Central Valley Regional Water Quality Control Board
30/31 July 2015 Board Meeting

Response to Comments
for the
Sacramento Regional County Sanitation District
Sacramento Regional Wastewater Treatment Plant
Tentative Order Amending Waste Discharge Requirements

Figure 1. Sacramento River Hardness vs Flow

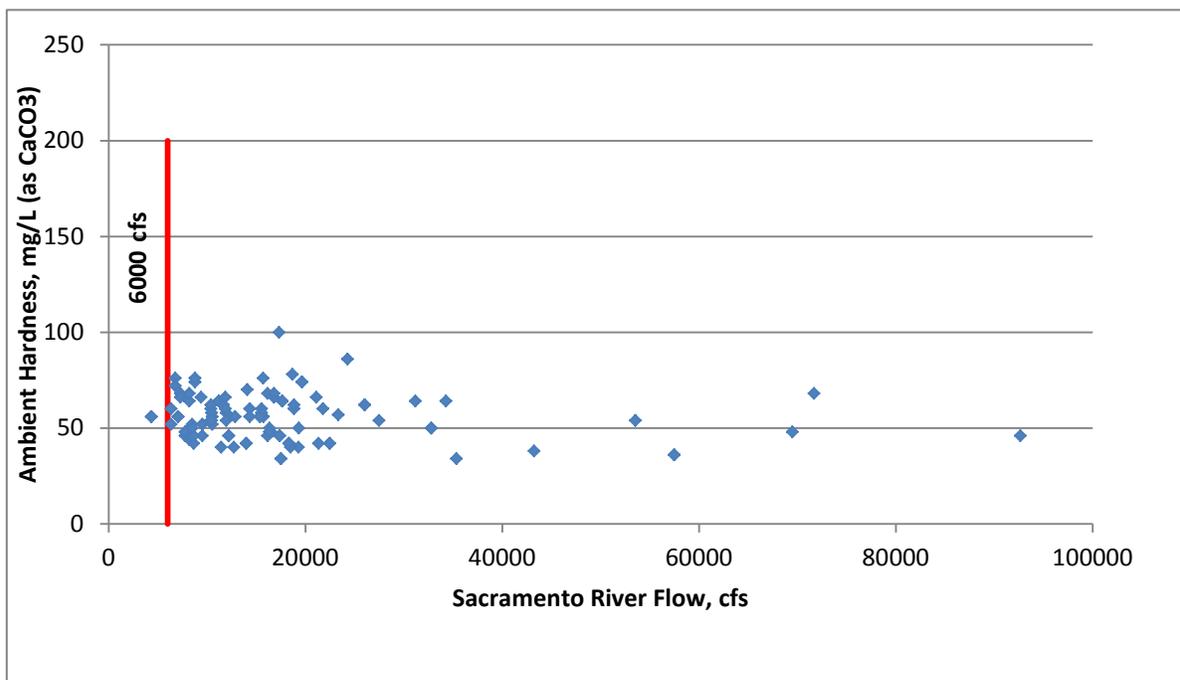
Selects a technically unjustified high hardness value to represent a worst-case scenario
CSPA comments that, “*The Regional Board has failed to use valid, reliable and representative data in developing limitations, contrary to the cited Federal Regulation.*”² Central Valley Water Board staff disagrees. The Regional Board used a 10 year record of hardness data measured upstream and downstream of the discharge, which includes a total of 145 data points. Ten years of data from January 2005 to December 2014, is a reasonable dataset that adequately represents the hardness of the receiving water.

The receiving water hardness (actual ambient hardness) ranged from 34 mg/L to 100 mg/L over this time period. The hardness of the receiving water was evaluated under the design low flow conditions as required by the CTR. Figure 1, below, is a plot of receiving water hardness as a function of river flow. The chart demonstrates the hardness is highly variable and there is no relationship between hardness and flow. CSPA agrees, “*...review of monitoring databases shows that lower and higher hardness levels can be found under both low and high flow conditions.*”³
